Date: May 19, 2006

To: T10 Committee (SCSI)

From: George Penokie (IBM/Tivoli)

Subject: SAM-4: Converting to UML part 1

Figure 4 — Logical unit class diagram

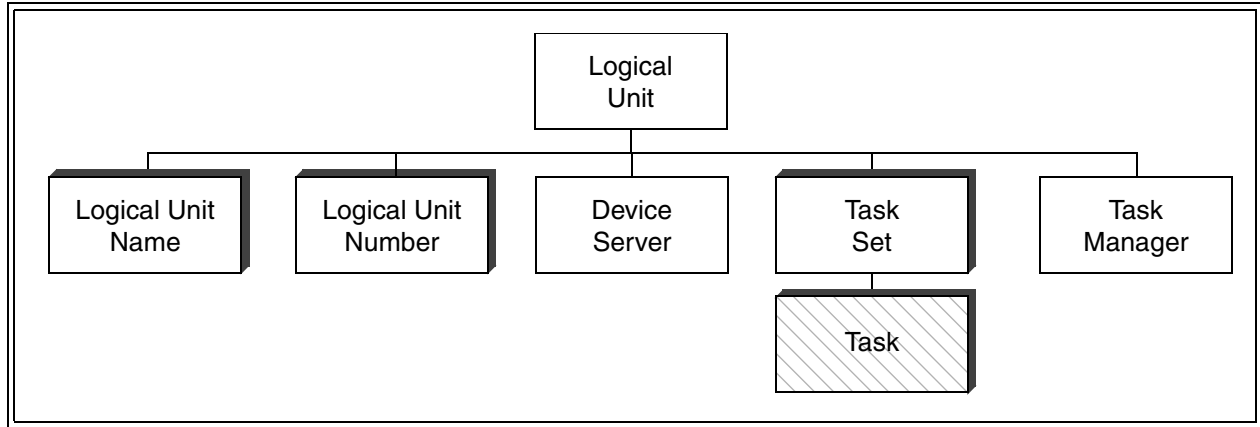
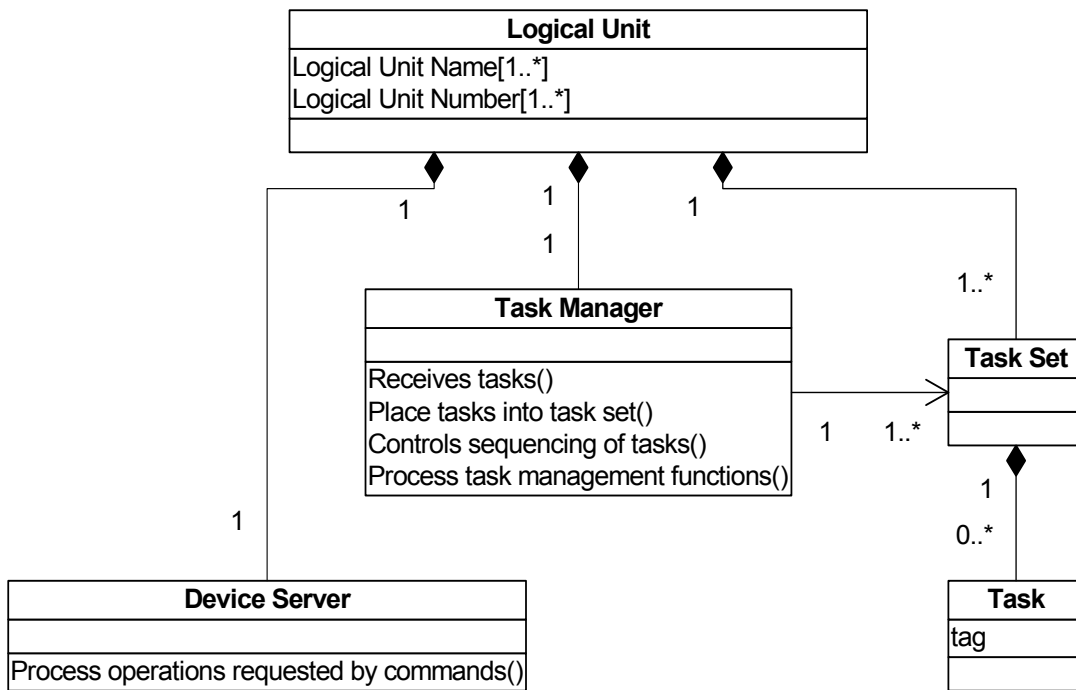
For an example of what figures in SAM-4 would look like a converted logical unit model (see figure 3) as currently shown in SAM-4 would look like what is shown in figure 4.
